LETTER REGARDING NSB KINGS BAY GA REQUESTING PERMISSION TO DISCHARGE A
GROUNDWATER STREAM TO THE CITY OF ST MARYS WASTEWATER TREATMENT
SYSTEM
1/28/1994
NSB KINGS BAY

SUBJECT: Discharge to the City of St. Marys' Point Peter Plant
Naval Submarine Base, Kings Bay, Georgia
Contract Task Order #041
Contract N62467-89-D-0317

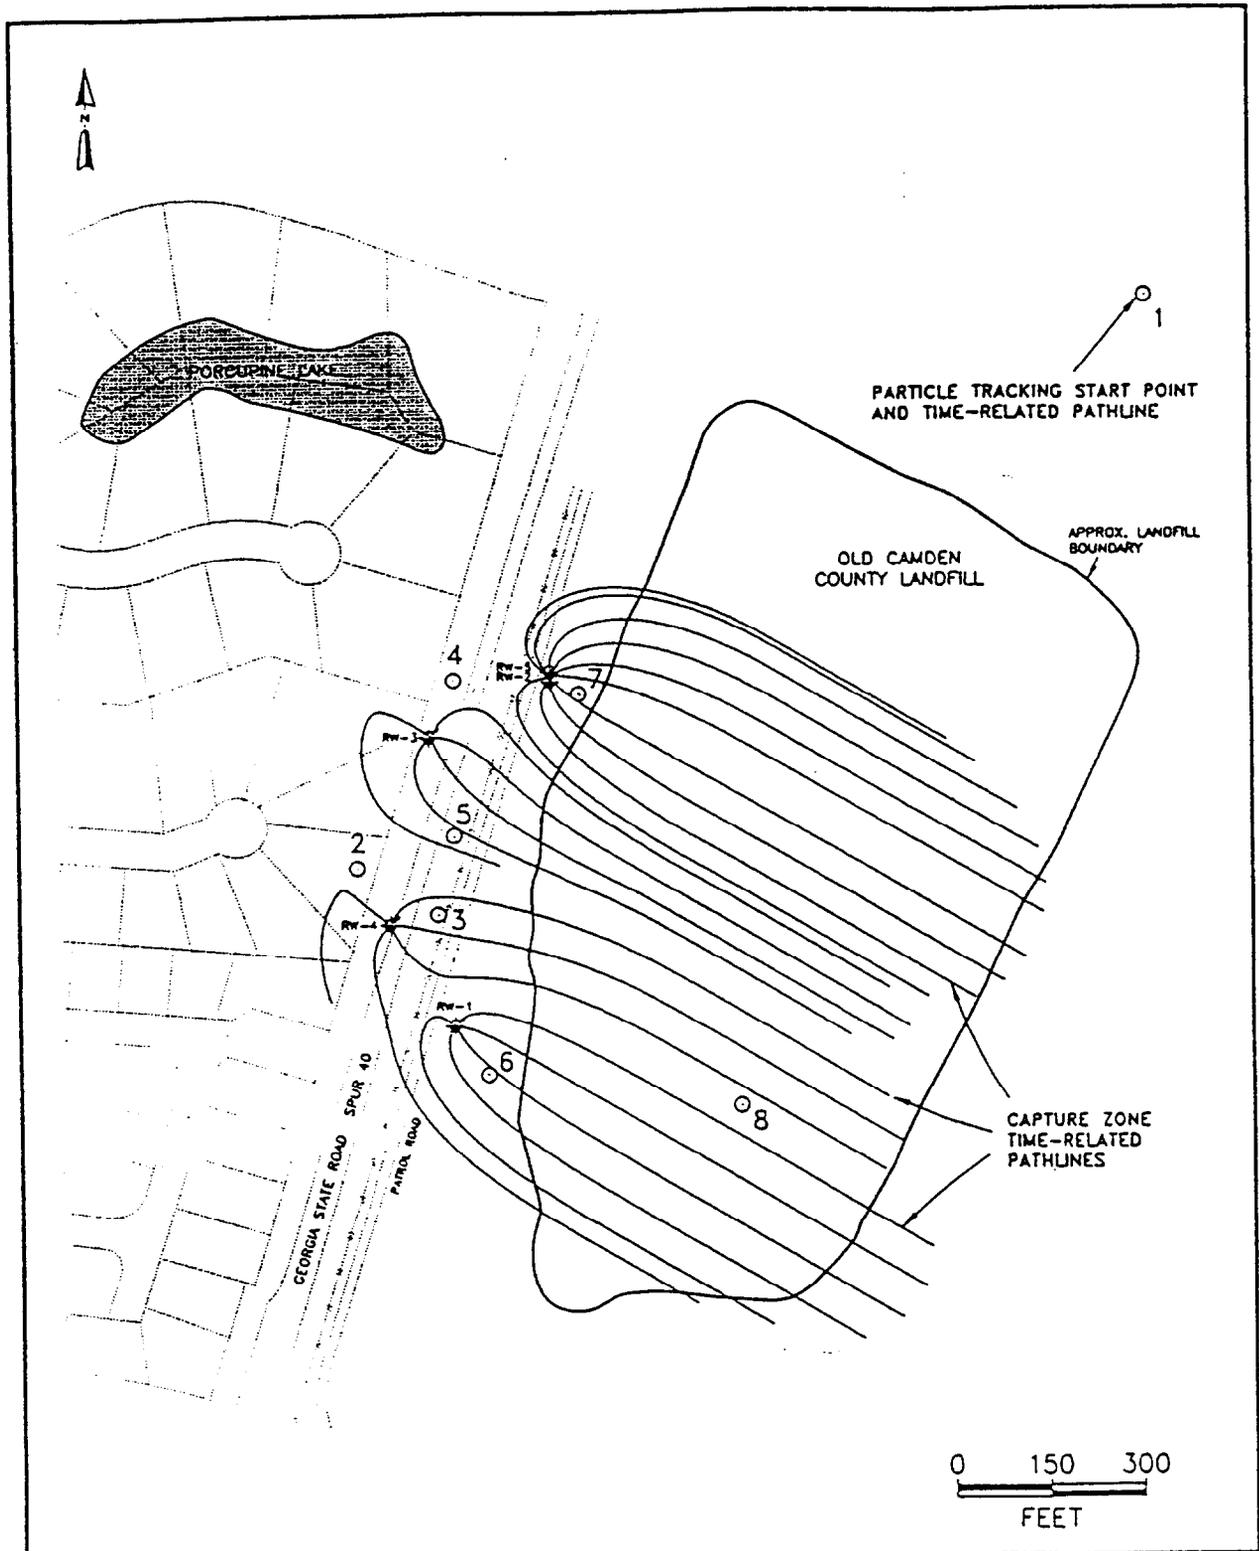
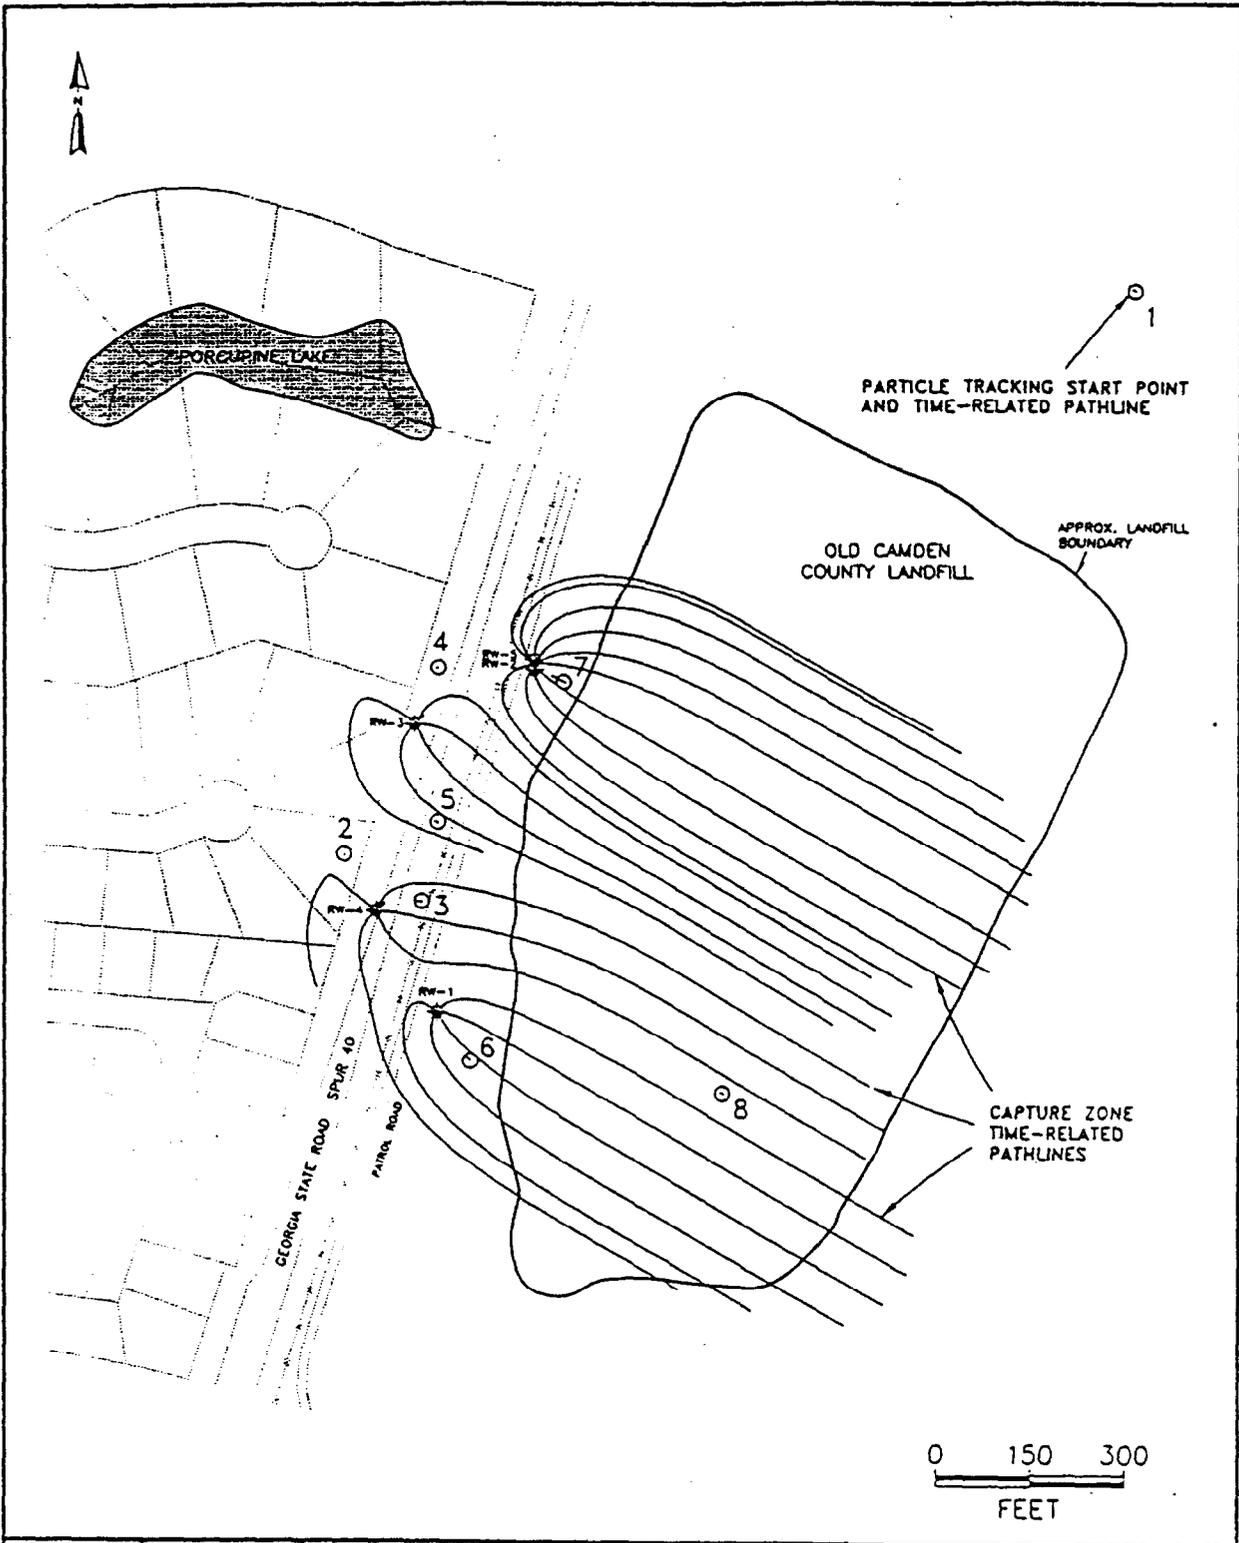
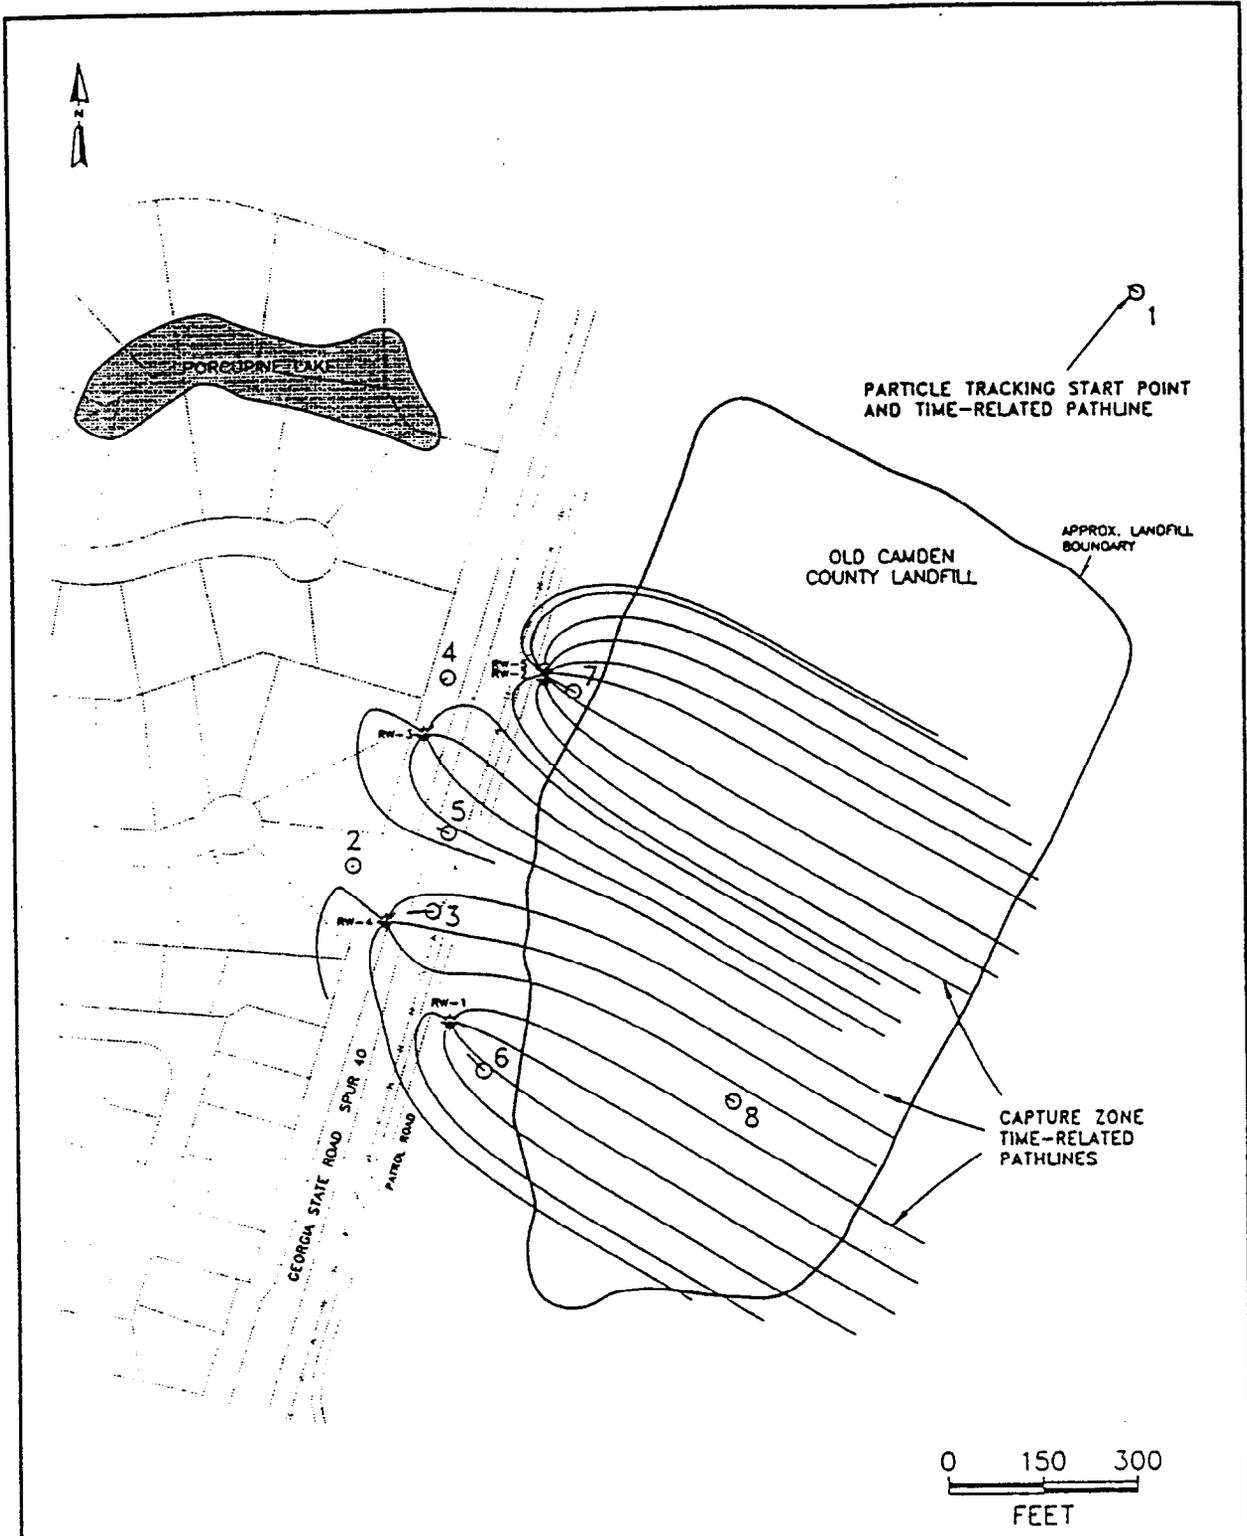
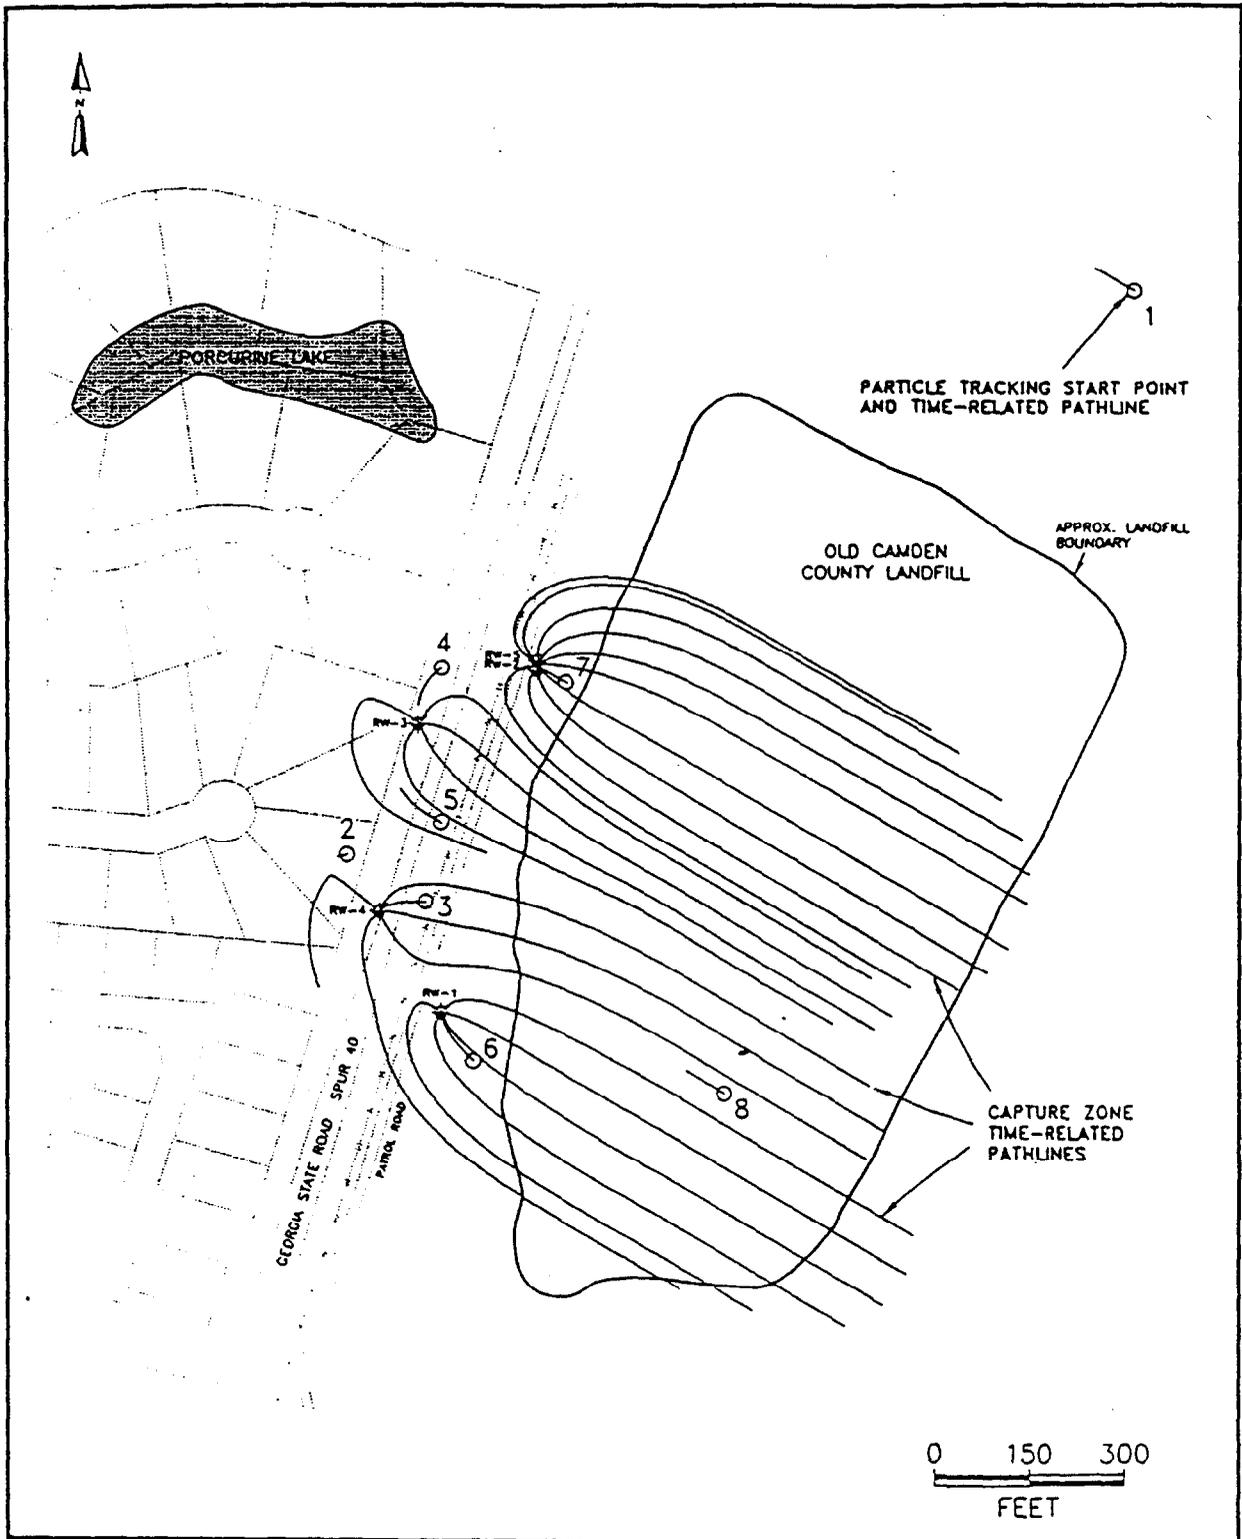
Comment 2c: Implement operating controls. During the 8 month operating period, the only proposed control is a weekly effluent sample with a one-week laboratory turn-around time. It is possible for an exceedance not to be discovered for two weeks. We recommend that some combination of on-site effluent retention and enhanced analytical frequency be implemented to allow confirmation of effluent quality prior to discharge.

Additionally, some type of rapid operational monitoring is recommended. This might consist of monitoring selected indicator parameters such as pH, specific conductivity and/or total organic carbon (TOC).

Response: During discussions between the Navy and MSE held on 5 November 1993, MSE expressed that daily monitoring of an indicator parameter (for example, TOC) would preclude the use of effluent retention. Modeling could also show that only gradual variations in groundwater chemistry or contaminant concentrations are anticipated from pumping the aquifer.

The model used to show the movement of a "slug" of contamination within or around the capture zone of the groundwater extraction wells was the two-dimensional semi-analytical General Particle Tracking Module (GPTRAC) from the USEPA's Well Head Protection Area (WHPA) delineation code. Using this model, slugs of contamination or chemical variations of the groundwater can be represented as particles transported by advective movement through the aquifer. GPTRAC models the movement of particle(s) of constituents through the proposed recovery wells' capture zones using analytical velocity computation techniques. Distance traveled therefore is time-dependent.

Several plots of the five-well recovery system and its effective capture zone are provided as Figures 1 through 5. These plots show the movement of "slugs" of constituents from seven arbitrarily selected locations within the plume. Particle #1 in each figure represents a particle within the zone unaffected by the groundwater

extraction system, or the baseline particle movement. The projected particle pathway for each model duration (7 days, 30 days, 90 days, 1 year, and 5 years) is shown to begin at the indicated circles. The pathways which appear as dots in the shorter durations are lines indicating travel distances.

The modeling shows that because of the relatively low seepage velocity within the aquifer, current groundwater quality will be representative of groundwater quality for the duration of the initial operations of the IM. Plume characteristics are expected to change slowly; however, the changes during the initial operations of the IM will be gradual enough for weekly monitoring to be sufficient to detect and respond to the changes. Vinyl chloride will be the greatest indicator of change in plume characteristics since it is a degradation product for most of the chlorinated organics present in the aquifer.
